MEMORANDUM

RE: Comments on the NMFS/UW Draft report entitled, "Survival Estimates for the Passage of Spring-Migrating Juvenile Salmonids Through Snake and Columbia River Dams and Reservoirs, 2001".

The Fish Passage Center (FPC) staff has reviewed the NMFS draft report entitled, "Survival Estimates for the Passage of Spring-Migrating Juvenile Salmonids Through Snake and Columbia River Dams and Reservoirs, 2001". We appreciate your agreement to extend the deadline date for receipt of comments from January 31 to March 1 to allow us to complete our review comments. We offer the following comments for your consideration in completing the final report. We request that, as is required by other Bonneville Power funded studies, that these comments and an explanation of how they were addressed be appended to the final report.

Figure 1. NMFS season survival estimates Lower Granite Dam tailrace to McNary Dam tailrace for yearling chinook from 1995 to 2001 plotted with average flows during BiOp flow period in Snake River.

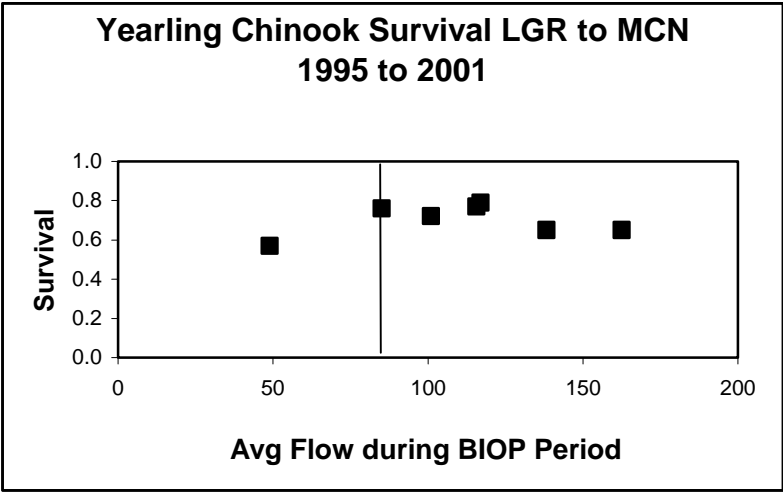
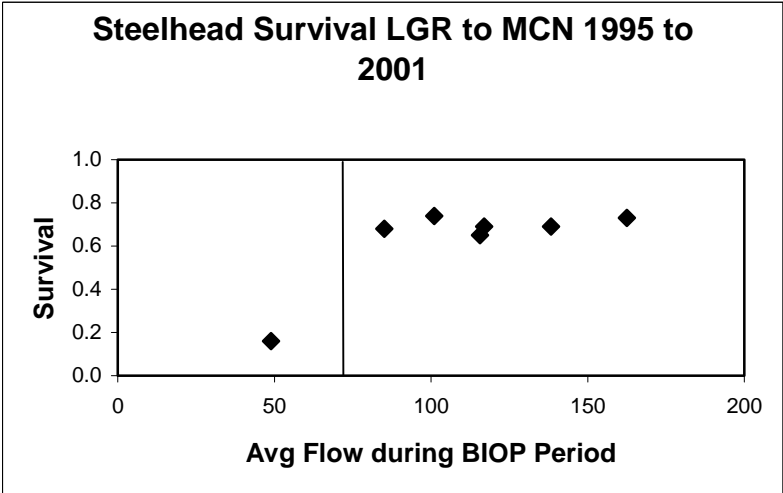
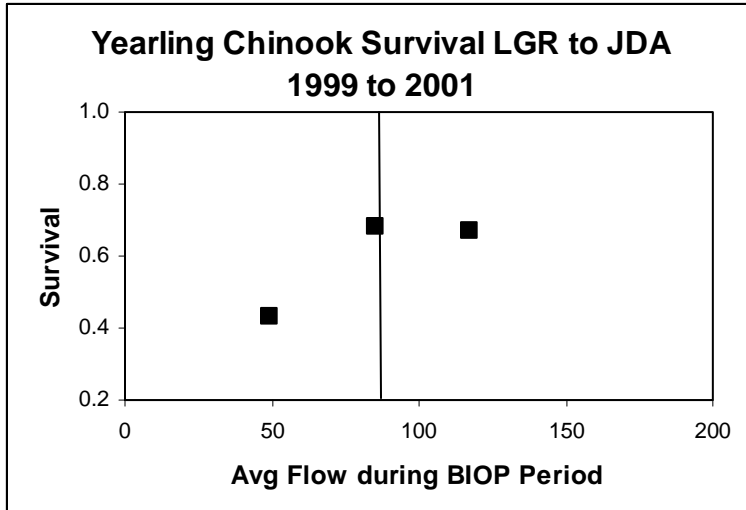
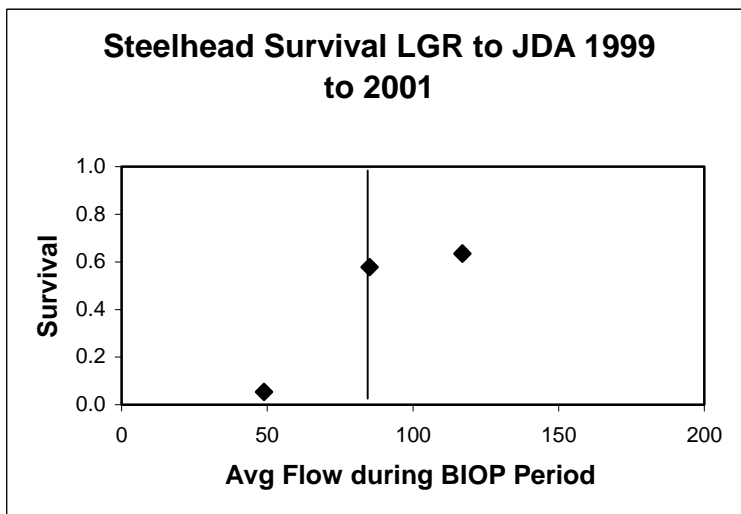
An alternate means of comparing survival among years may include observations for the longest reaches over which survivals have been estimated for all years, compared to seasonal flow conditions. In this analysis the flow index was average discharge during the period that the BiOp sets spring targets for flow and spill at the Snake Projects. Flow is compared to seasonal survivals for the years 1995 to 2001 for the reach LGR to MCN, and for the years 1999 to 2001 for the reach from LGR to JDA. (These are the only years for which PIT-tag survival estimates were calculated for these entire reaches.) As can be seen in Figure 1, the LGR to MCN survivals of yearling chinook remain above 65% for the years 1995 to 2000, when flows are at or above the BiOp flow target of 85 kcfs during the BiOp spill season, but fall to 57% in 2001. For steelhead, the LGR to MCN reach survivals also remain above 65% when flow targets were met and plummet to 16% in 2001, when target flows were well below the BiOp target spill levels (Figure 2). For the years 1999 to 2001 there was sufficient data available for the longer reach LGR to JDA. Plots comparing those years (Figures 3 and 4) do show a similar trend to the shorter reach; survival in 2001 was considerably lower than 1999 and 2000.

NMFS presents a relatively short-time series of survival vs. flow data (1993-2001). With the exception of 1994 and 2001 the average flow exceeded the Biological Opinion flow targets. The Biological Opinion flow targets were specifically chosen based on data that showed little change in survival with flow above the targets. Consequently, rather than showing a no flow/survival relation, the data are validating those upon which the flow targets were based. In Figures 3 and 4, NMFS season survival estimates Lower Granite Dam tailrace to John Day Dam tailrace for yearling chinook and steelhead respectively from 1999 to 2001 are plotted with average flows during BiOp flow period in Snake River.

Figure 5a. Yearling Chinook Survivals MCN to JDA tailwater, Spill proportion at JDA, and Average Total Discharge at John Day during pre-spill, spill and post-spill blocks at JDA 2001.

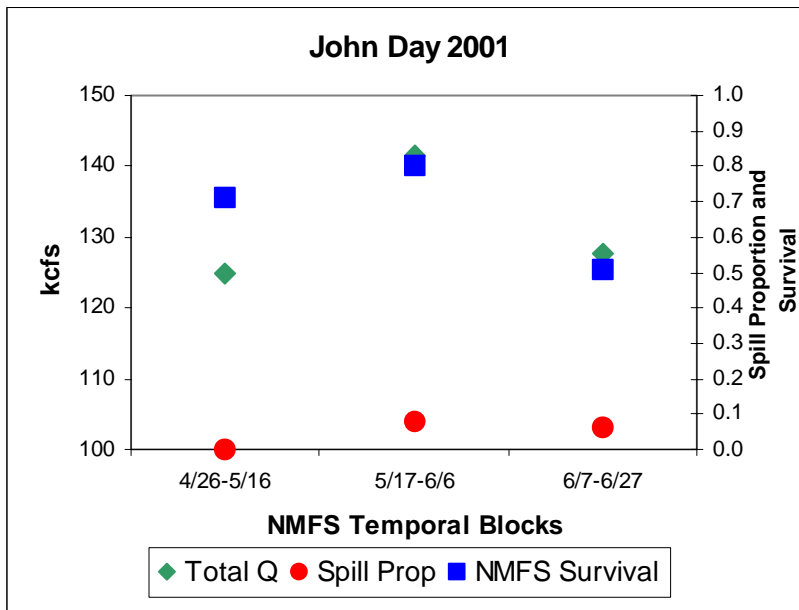
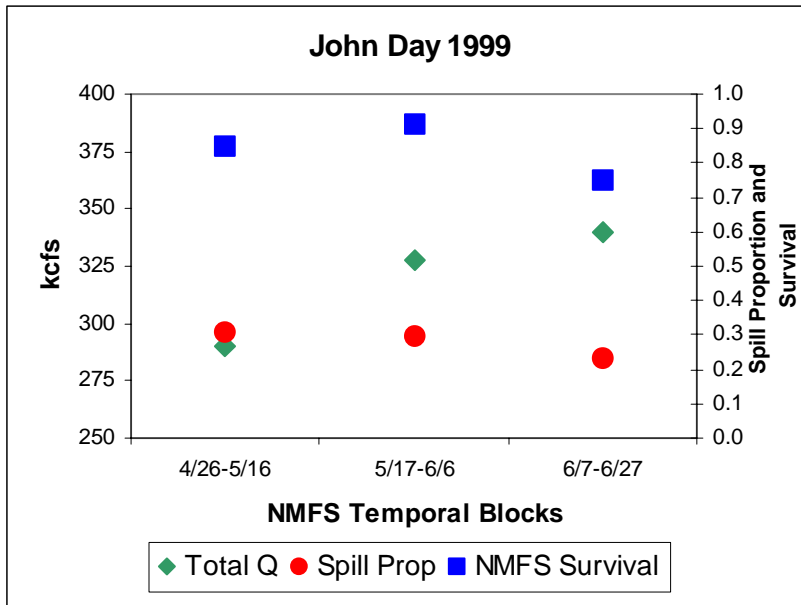
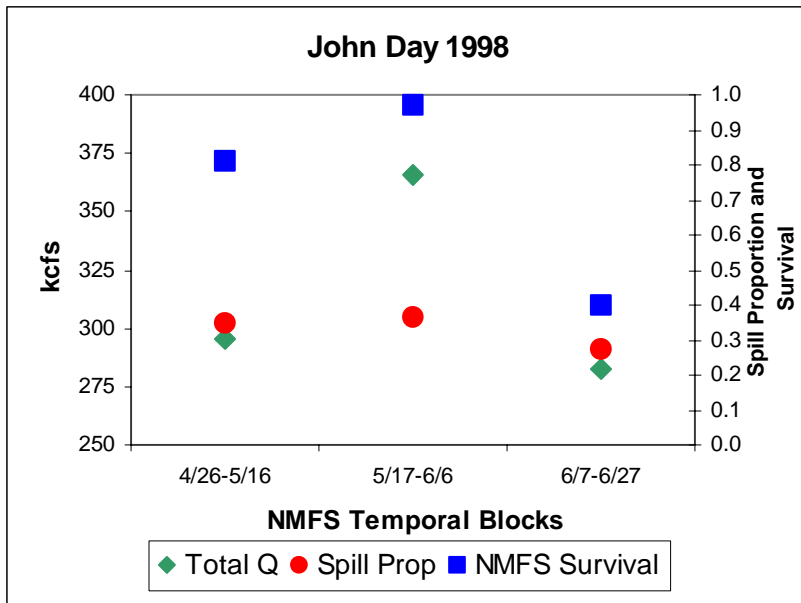
A temporal effect cannot be demonstrated unless flow and spill remain relatively stable over that period each season. Flows and spill did not remain constant during these time periods. In fact, using the time periods NMFS blocked for their presentation to NWPPC we found the highest survivals occurred during the periods of the highest flows and spill proportions in 1998 and 2001 (Figures 5 a,b,c). In 1999, the differences in survival were the smallest among the three periods. In that year spill was manipulated in blocks of low and high daily spill during early May and was more consistent during the second time period (May 18 to June 6) and decreasing in the

third block. Also, flows increased over the three blocks while proportion spilled decreased. So that some positive effects of high flows and higher spill proportion might counterbalance each other, resulting in more moderate differences in survivals throughout the season. The historical data presented by NMFS could be considered an indication that temporal patterns of survival

might be attributed in part to an increase in flow and spill proportions through the passage season. Neither the NMFS presentation nor their annual report recognized this possibility. These findings support the assertion that high flows and spill improve survival.
